Memorandum

Subj: Mediterranean Village – Coral Gables, Florida
Responses to Outstanding Transportation/Parking Items

The purpose of this memorandum is to provide updates/responses addressing outstanding transportation/parking related items identified by City Planning and Zoning staff the week of May 18, 2015. Note that this memorandum serves as a follow up the supplemental information provided to City staff on the traffic impact study, valet operations study, and shared parking study dated May 18, 2015. The following summarizes updates/responses to these outstanding items:

ATTACHMENT A:
RELOCATED EASTBOUND VALET STAND ON
PALERMO AVENUE

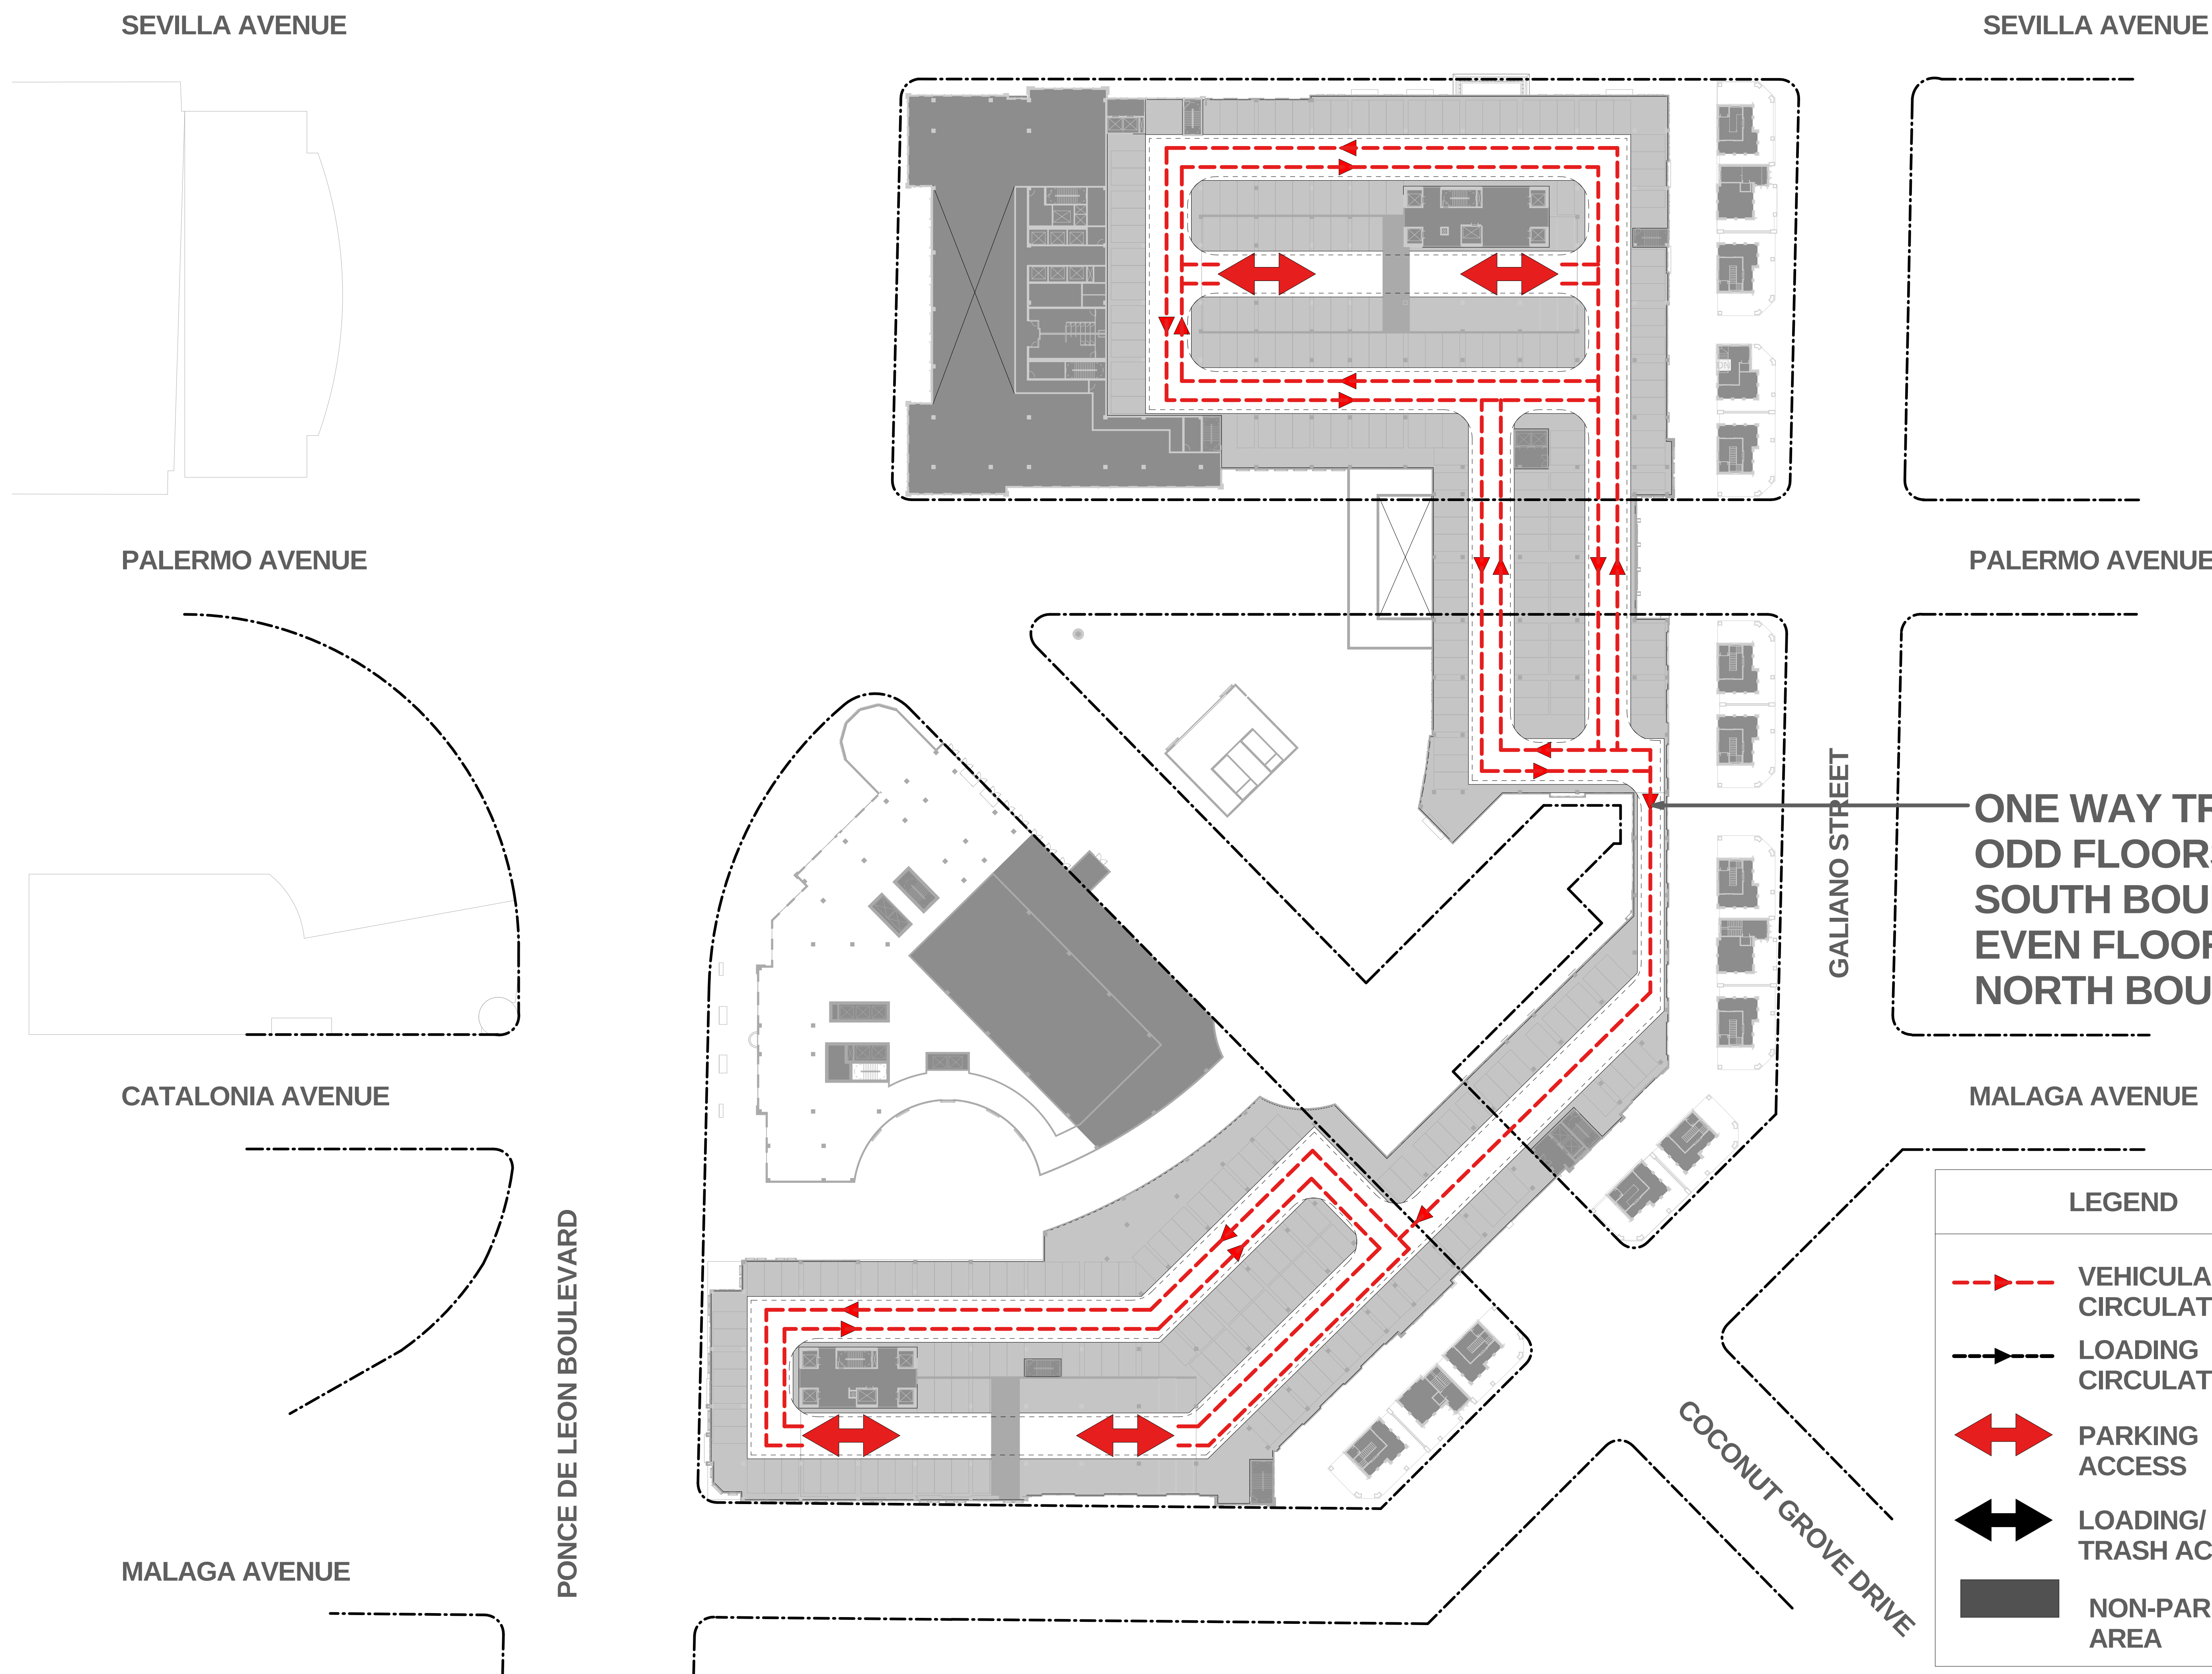
2. Eastbound Palermo Avenue Valet Station Relocation

Staff has indicated a desire to relocate the eastbound valet drop-off station along Palermo Avenue to the east away from the Arts Center. In response to this request, the valet station has been moved as far east as feasible while maintaining the same number of valet service positions. Refer to Attachment A.

ATTACHMENT B:
REVISED GARAGE CIRCULATION
PLANS FOR UPPER NORTH-SOUTH
CONNECTOR BRIDGES

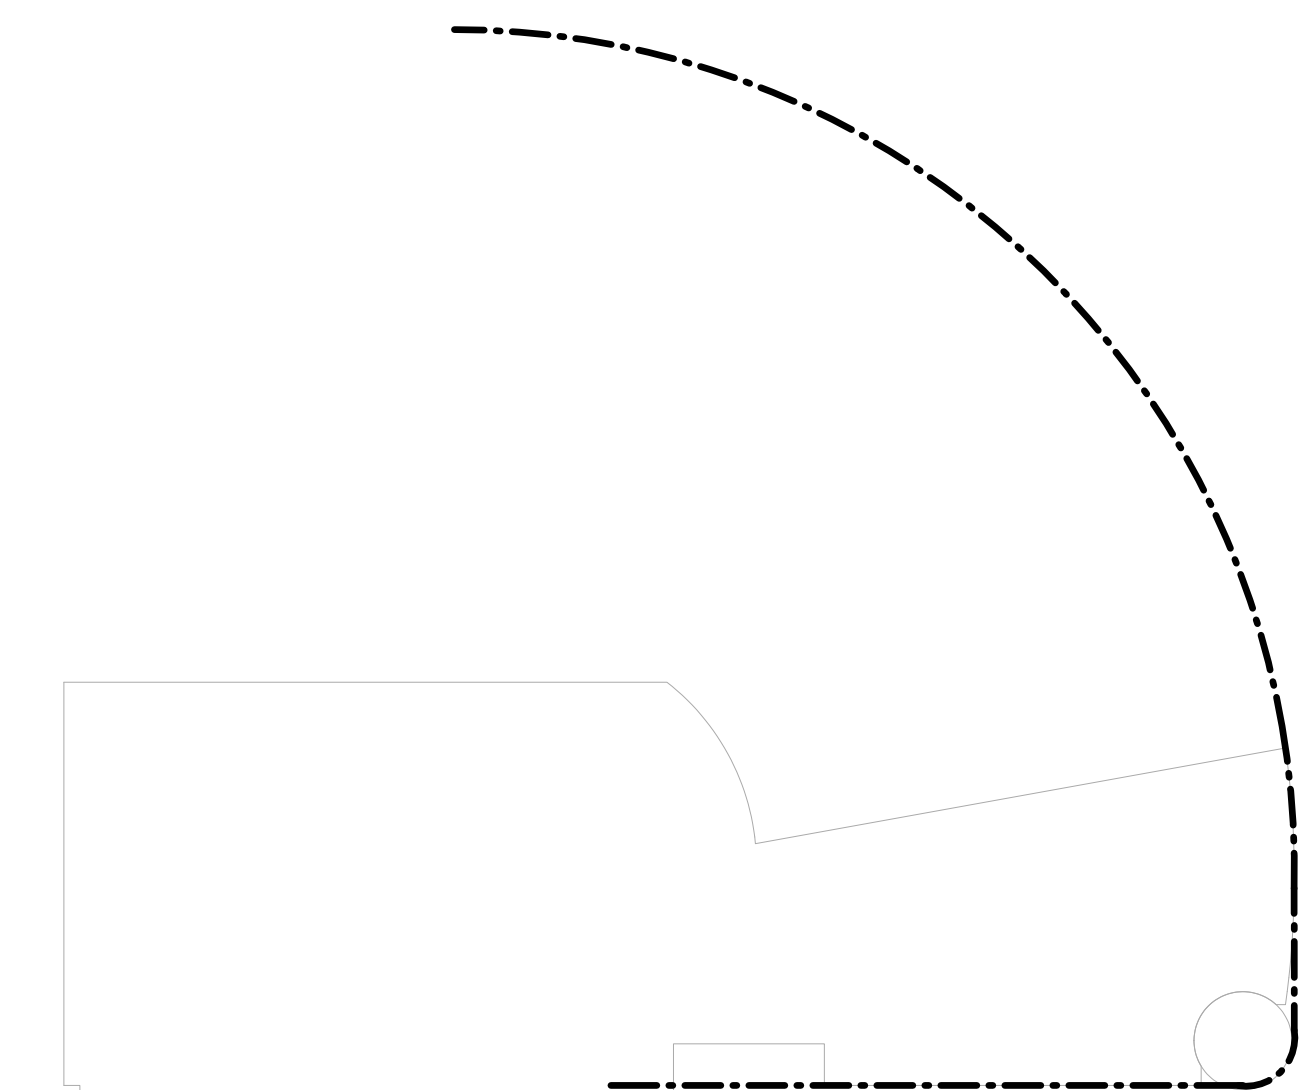
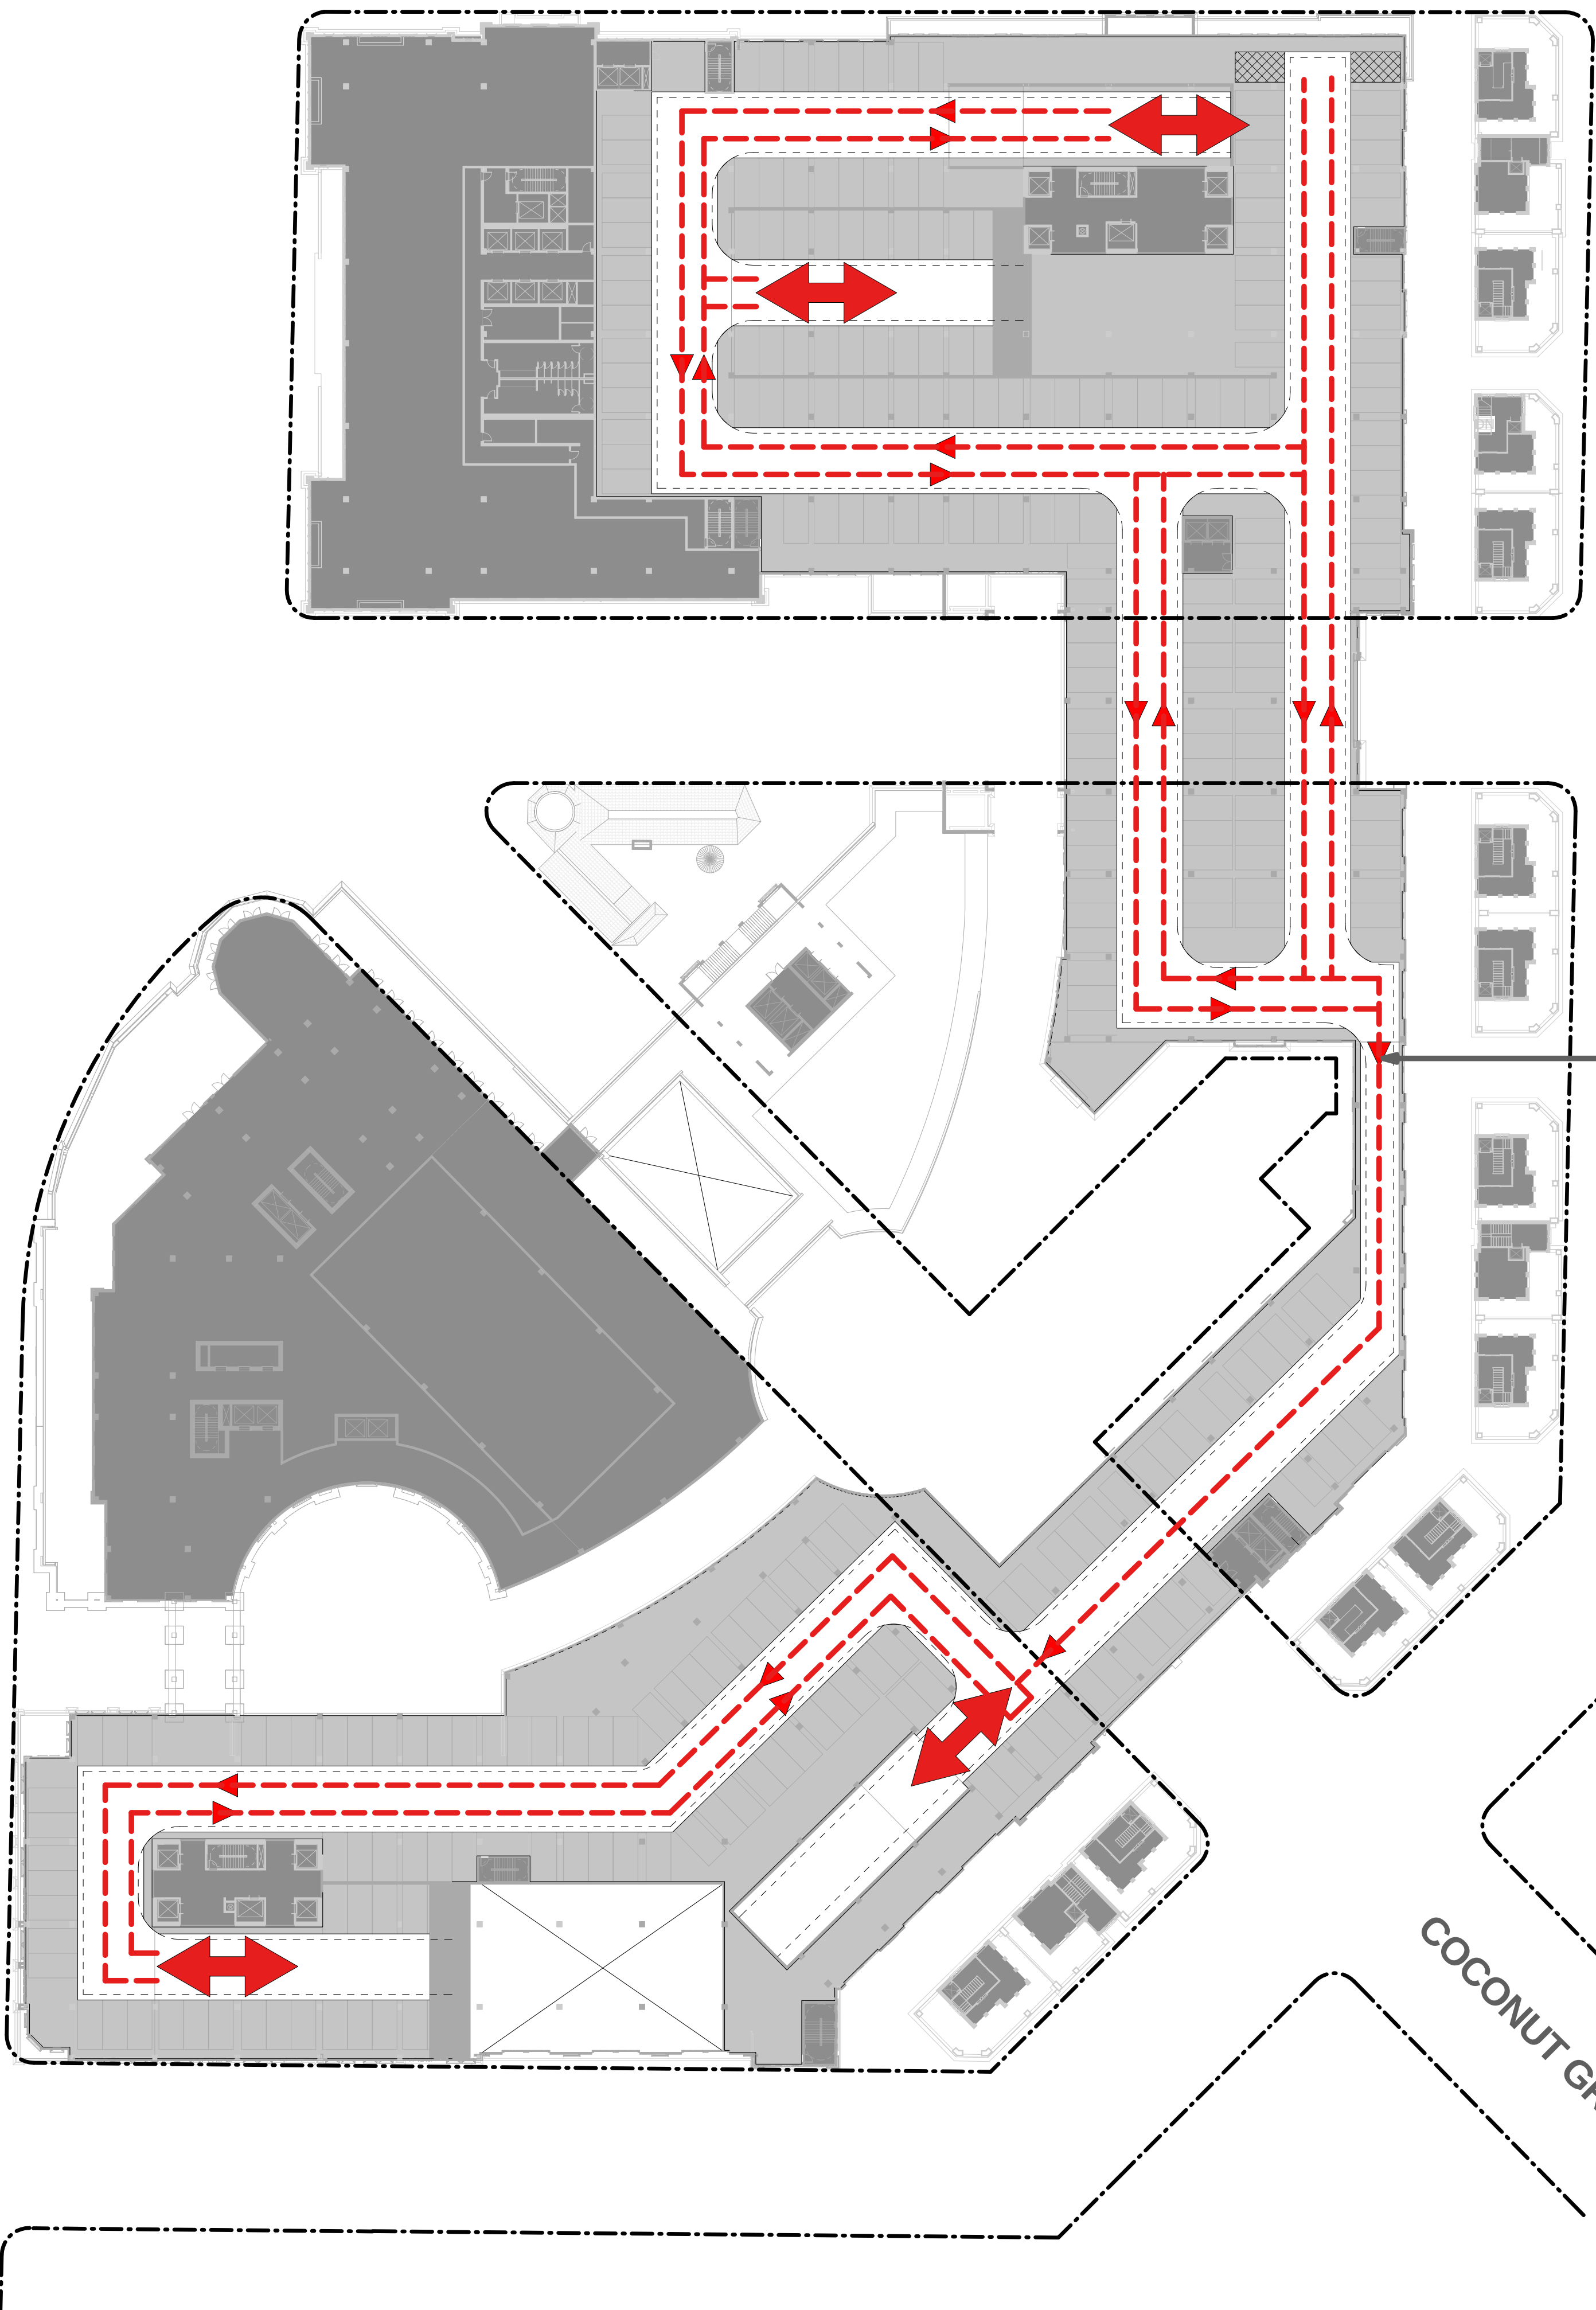
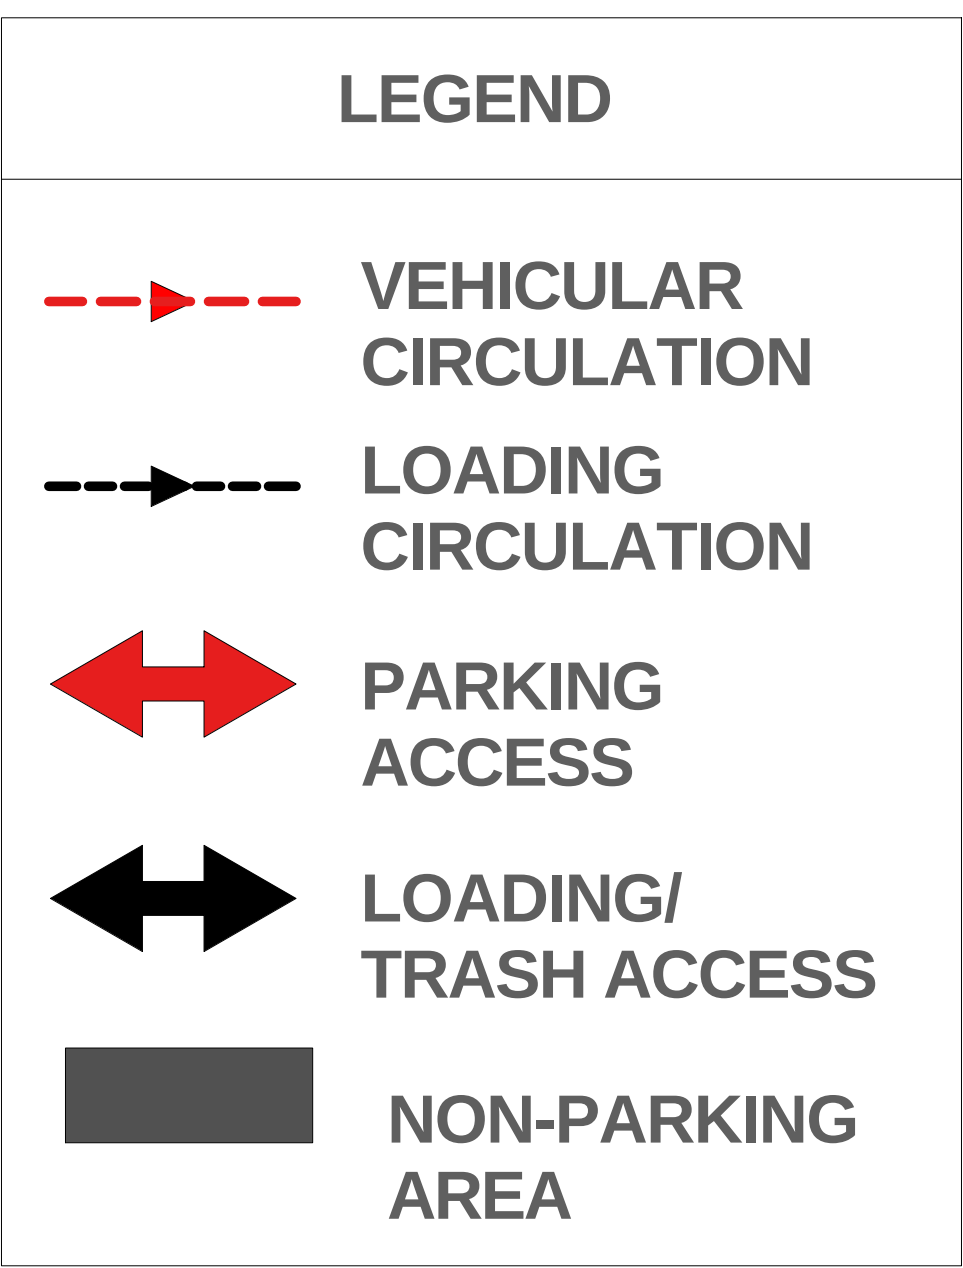
3. Parking Garage North-South Connector Bridges Traffic Flow Operations

Staff has indicated that the proposed two-way operation of the 15' wide north-south parking garage connecting bridges east of the Capote residence is not acceptable. Although two-way operation of these bridges is desirable, the revised plan proposes to operate these connectors as one-way facilities alternating the direction of flow on each floor (Floors 3-7). Wayfinding signage will be developed to direct patrons to the appropriate crossing locations for each direction of travel. Refer to Attachment B.

**ONE WAY TRAFFIC.
ODD FLOORS ARE
SOUTH BOUND AND
EVEN FLOORS ARE
NORTH BOUND**
